Work Order ID 89889

Item Name: Crosstube Turning Detail

DRAWING NO. D407-667-245	TITLE CROSSTUBE ASSY (407 HIGH AFT)	REV. F	DART AEROSPACE LTD ENGINEERING ORDER		D.E.O. NO. D407-667-245-F-1	SHEET NO. SHEET 1 OF 2	SCALE NTS
DRAWN <i>1</i>	CHECKED <i>90</i>	MFG. APPR. <i>E</i>	APPROVED <i>140</i>	DE APPR. <i>H</i>			
DATE 11.04.08	DATE 11.04.12	DATE 11.04.12	DATE 11.04.12	DATE 11.04.12	DATE 11-04-12

DRAWING NO. D407-667-245	TITLE CROSSTUBE ASS'Y (407 HIGH AFT)	REV. F	DART AEROSPACE LTD ENGINEERING ORDER		D.E.O. NO. D407-667-245-F-2	SHEET NO. SHEET 1 OF 1	SCALE NTS
DRAWN 9	CHECKED ASS	MFG. APPR. E	APPROVED MP		DE APPR. H		
DATE 11.09.07	DATE 11.09.19	DATE 11.09.19	DATE 11.09.19		DATE 11.09.19

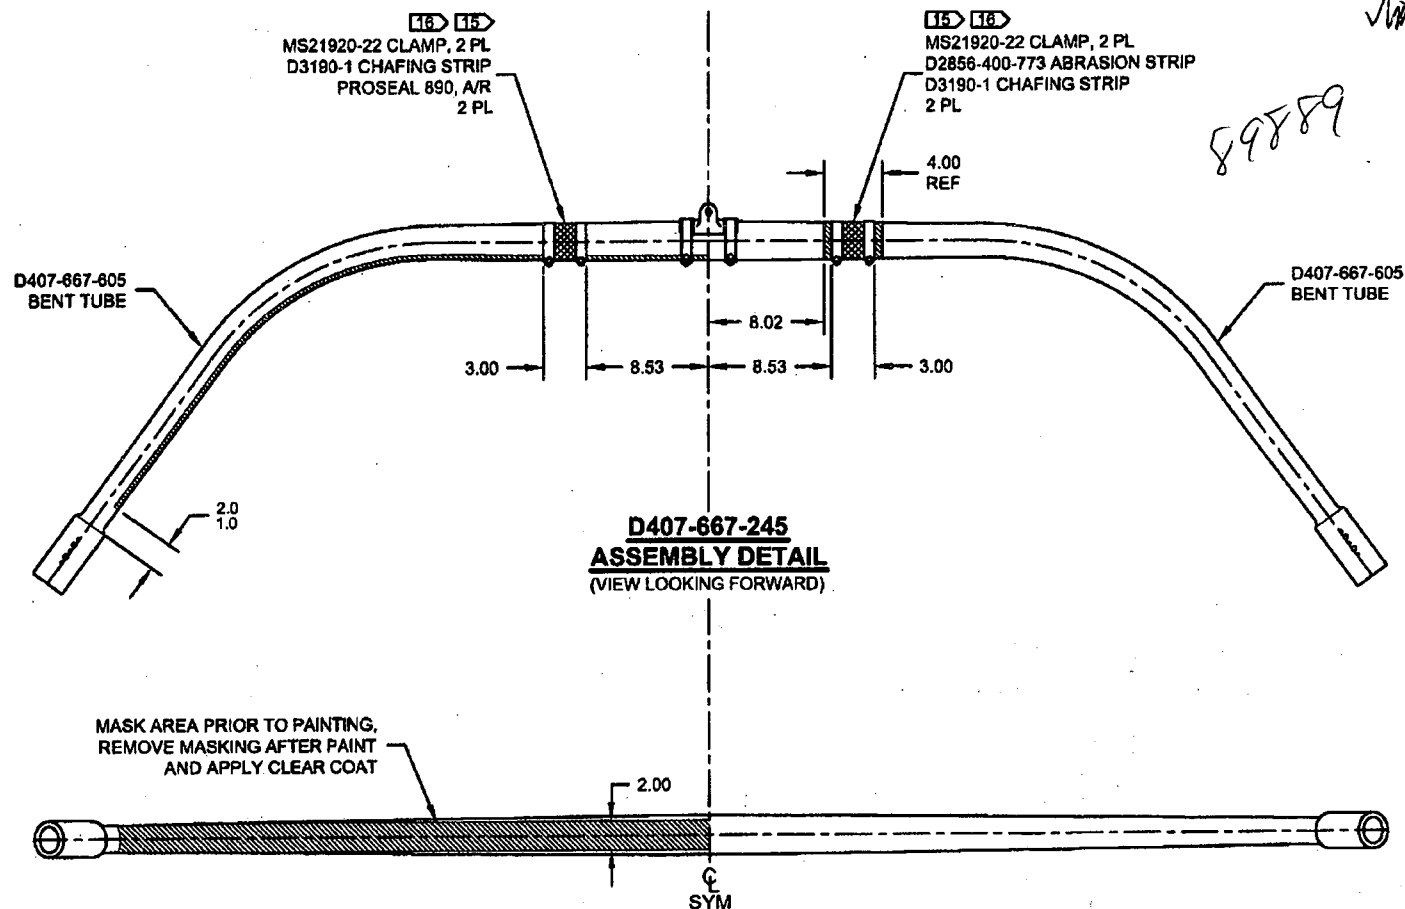
**PURPOSE:**

REMOVED ABRASION STRIP IN FAVOR OF A THIN LAYER OF PROSEAL 890.

IS:

WAS:
